Our Ref: 501.00271.00004
 Your Ref: W0291-01

RE: WASTE LICENCE APPLICATION – W0291-01 FORGE HILL RECYCLING LTD

Further to the Notice issued on 13th December 2016 in accordance with Article 14(2)(b)(ii) of the Waste Management (Licensing) Regulations, we submit the following information in relation to the above-referenced waste licence application.

Figure 1: Offsite noise monitoring stations NSL1-NSL3.

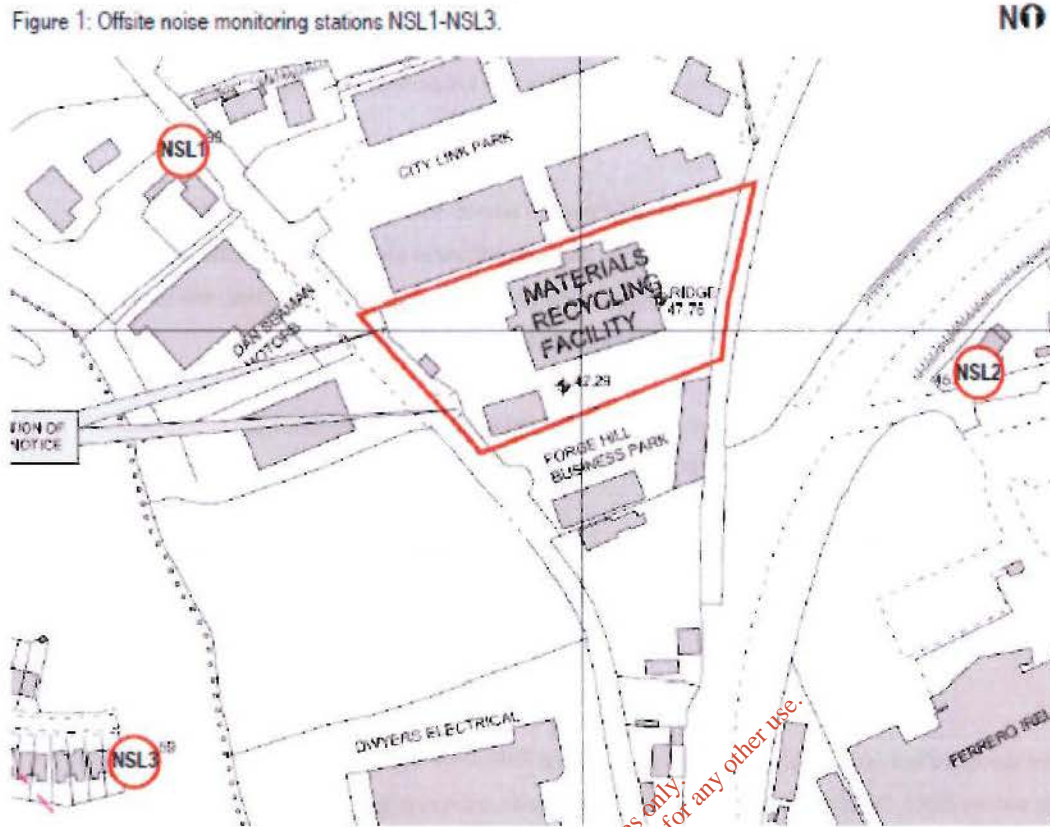
It is understood that the FHR waste facility permit is currently under review by Cork County Council. I propose that the opportunity be taken here to revise the noise monitoring positions. Condition 6.23 of the current permit allows for noise monitoring stations to be agreed with the local authority. Although the current permit refers to four measurement stations, the absence of local sensitive receptors is such that the three offsite stations NSL1-NSL3 are adequately representative. It is thus recommended that noise monitoring be undertaken in the future solely at the offsite stations NSL1-NSL3. These positions are shown in figure 1 over.

It is therefore concluded that (a) noise limits specified in the revised FHR permit will be most relevant if applied only to the offsite stations NSL1, NSL2 and NSL3, and that (b) routine noise monitoring should thus focus only on these receptors. It is also concluded that measurement at FHR boundary positions, and application of noise limits to same, will not be of any benefit to sensitive receptors, and will therefore be entirely superfluous and irrelevant.

Appendix 1: Noise stations

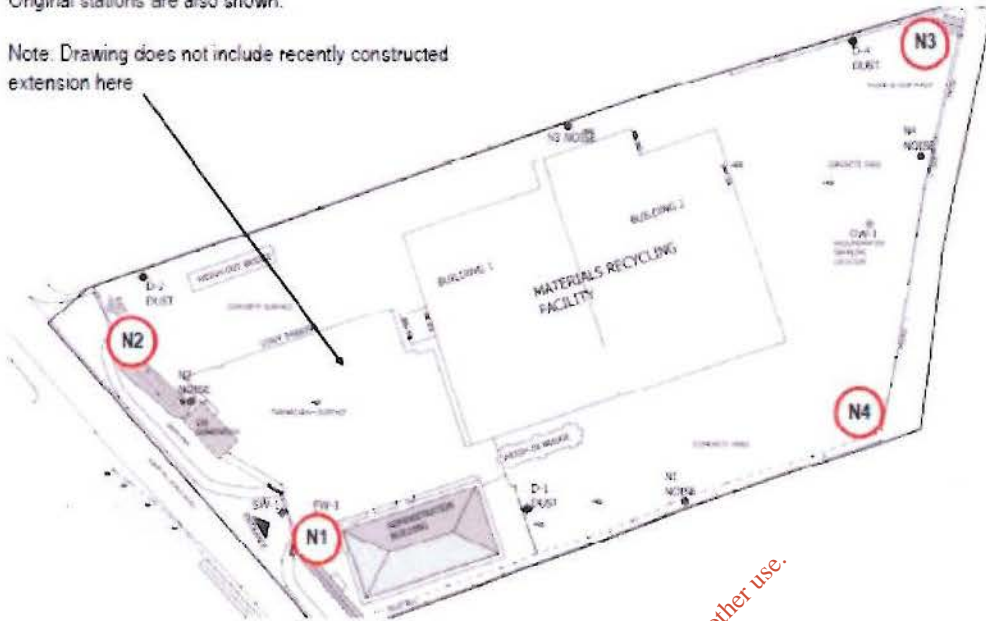
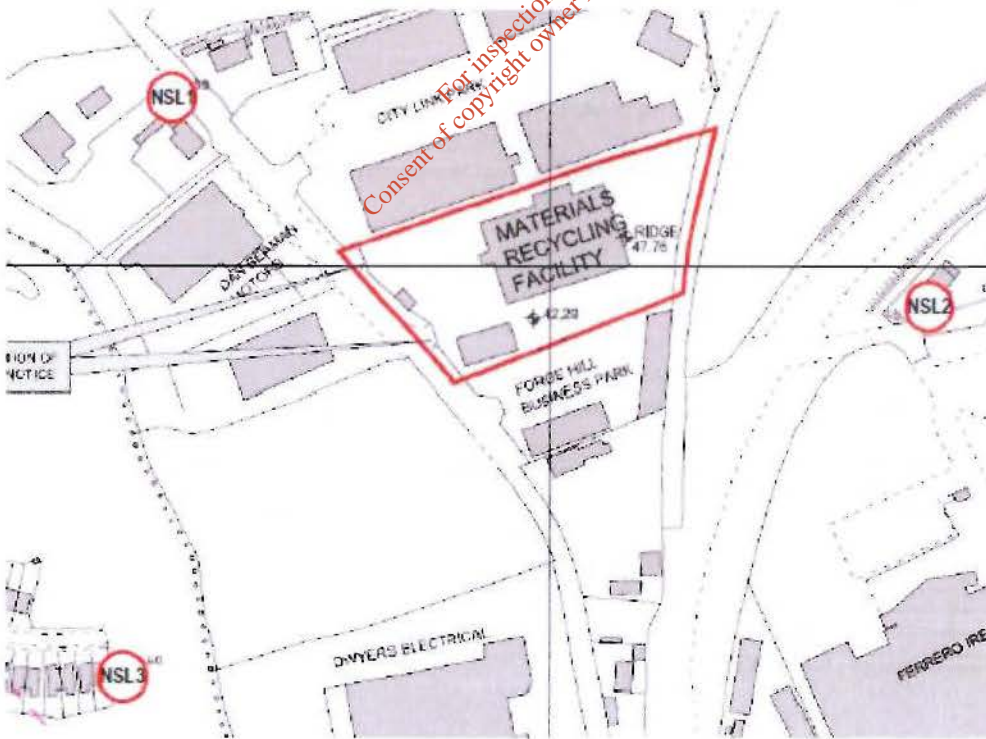
2.2 It is considered that the original onsite noise stations do not adequately represent the new site layout. It is thus proposed to revise the positions of these stations as follows:

2.3 The revised boundary positions, shown in **appendix 1**, were used during the noise survey described below. Monitoring was also conducted at three offsite stations (NSL1-NSL3), selected to represent the nearest noise sensitive locations, consisting of residential dwellings. The positions of these stations is also shown in **appendix 1**.

Scale	Date	Revision
1:250 @A1	SEPT 2015	R2
Drawn By: JB	Drawing Number: 4348-WL17

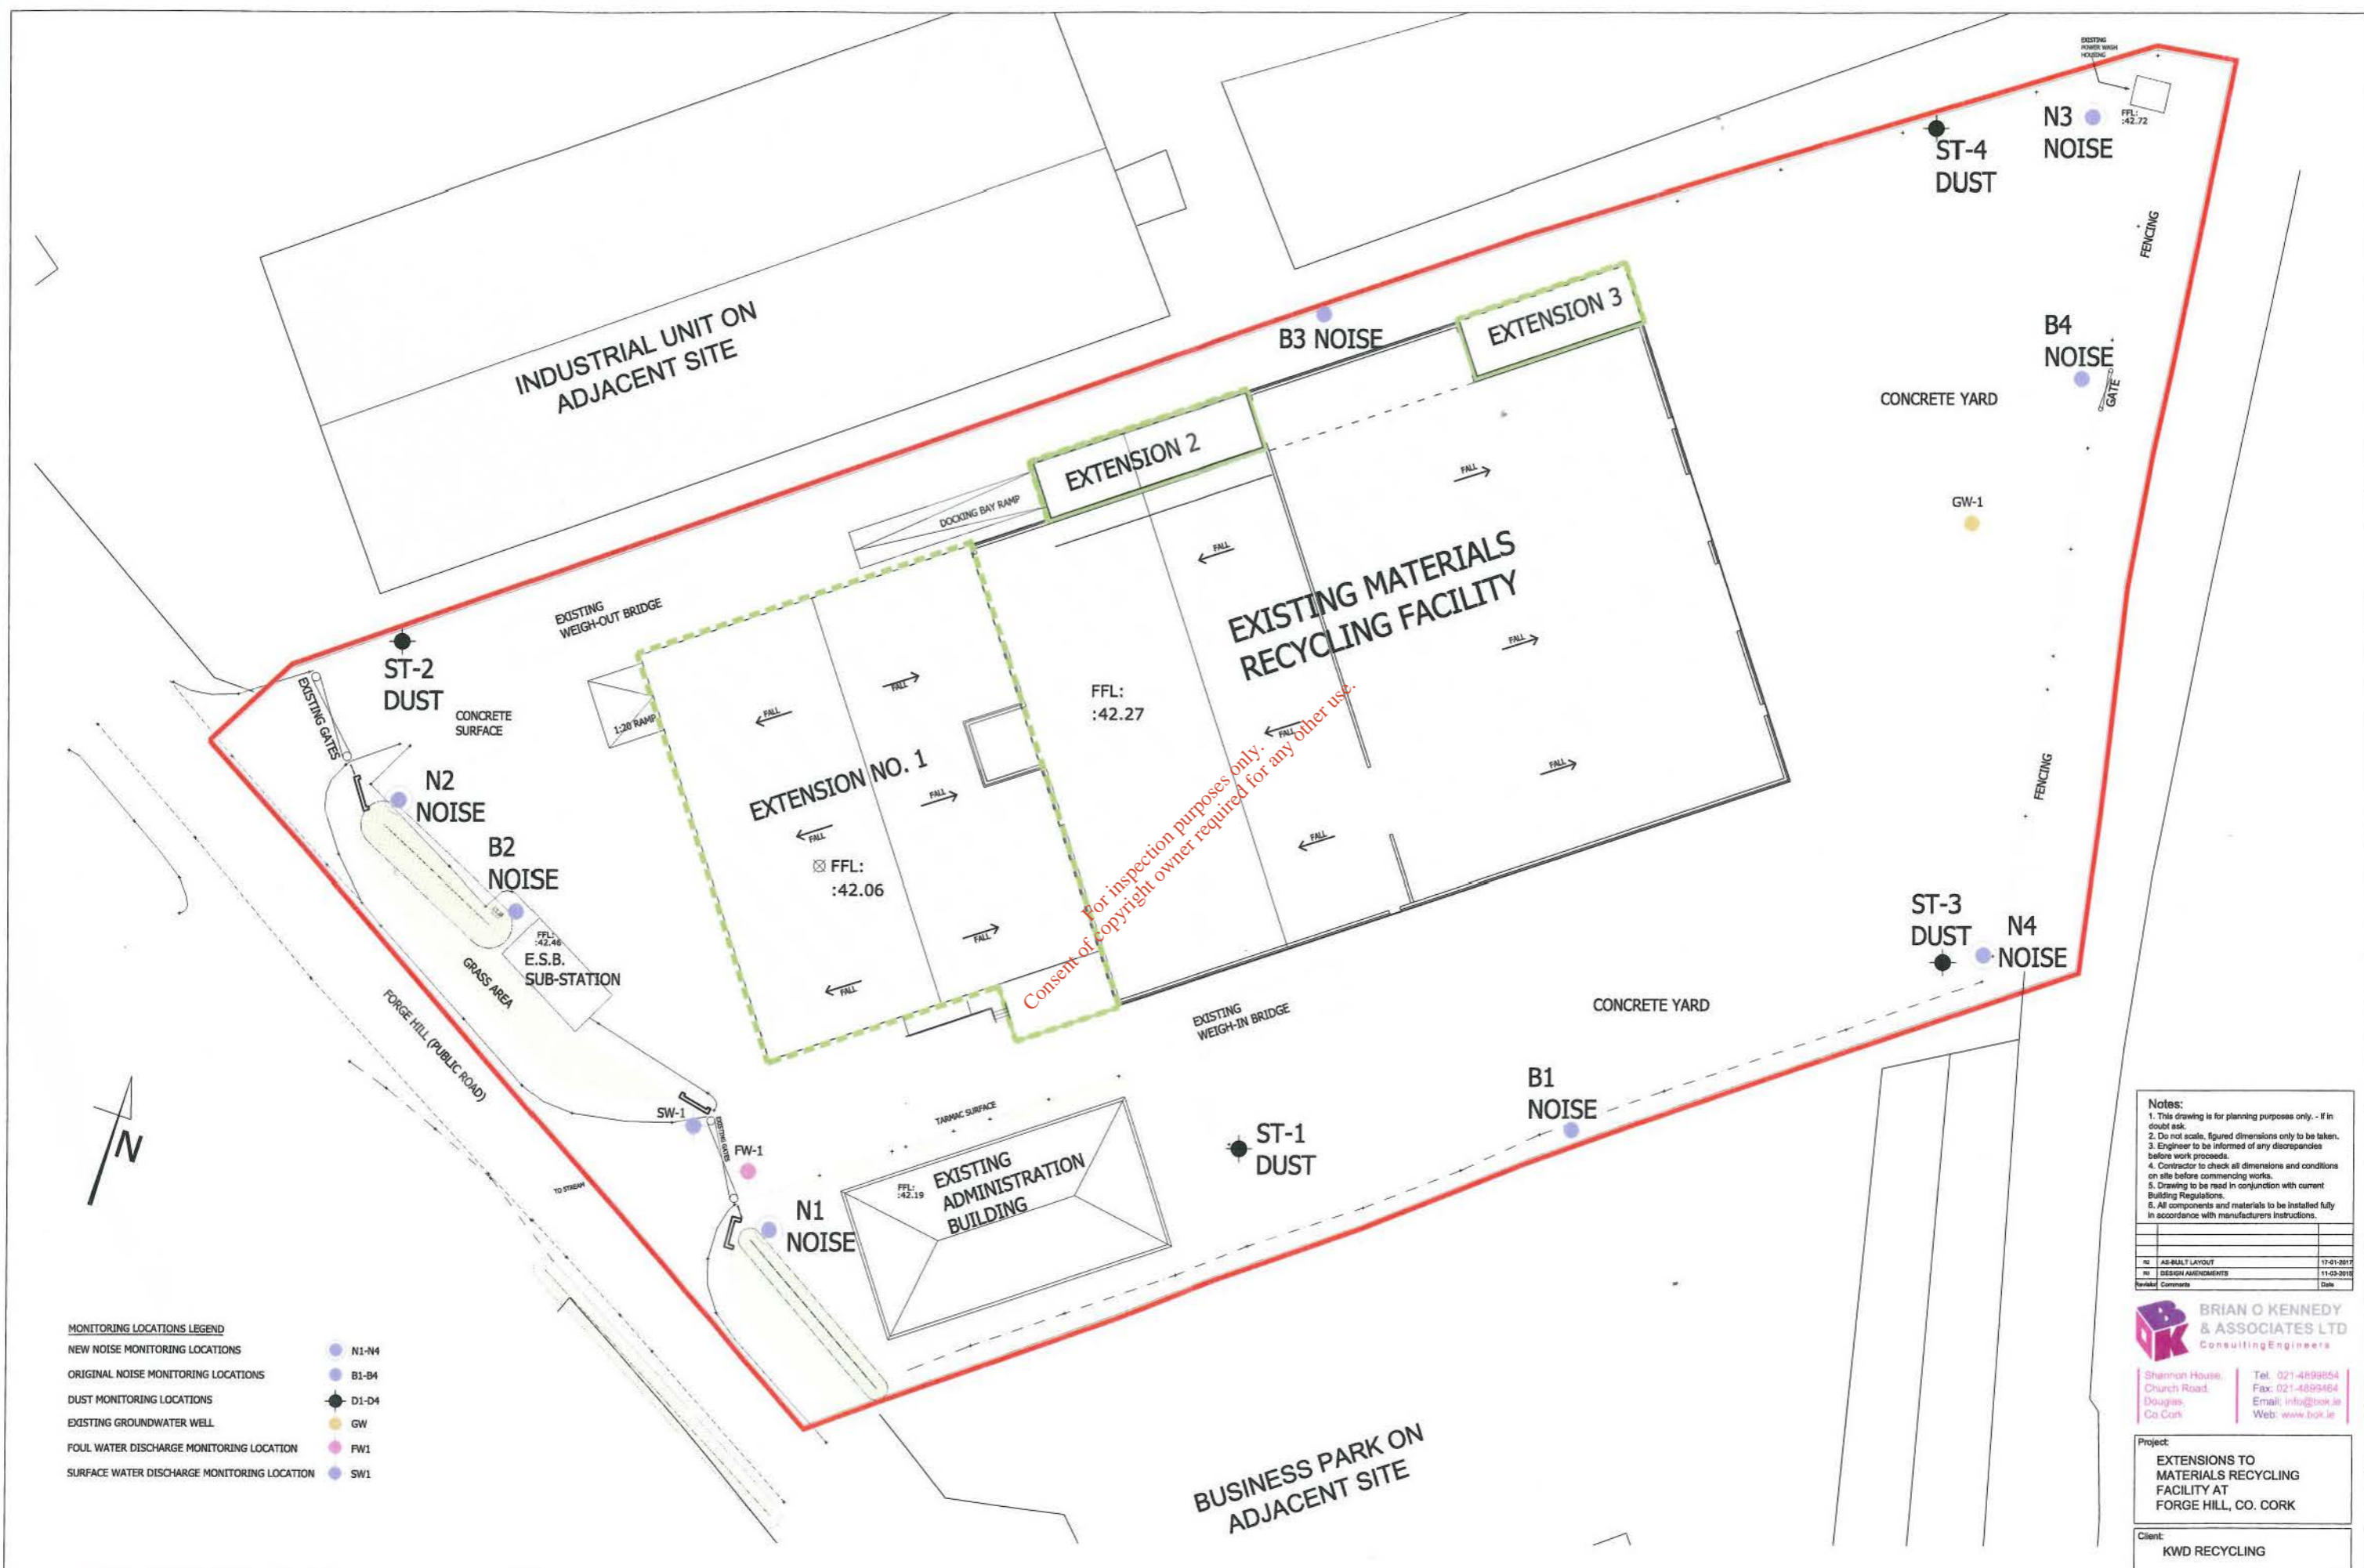
The revised site-boundary locations are shown on Drawing 4348-WL17 (Rev.2) in the 'Drawings' section of this submission and the new grid co-ordinates are provided in the revised Table below, which replaces the Table included in Section F (page 38) of the Waste Licence Application Form.

Title	Previously Submitted	Revised Now	Changes
Monitoring Locations	4348-WL17 Rev0	4348-WL17 Rev2	Revised Site Boundary noise monitoring locations
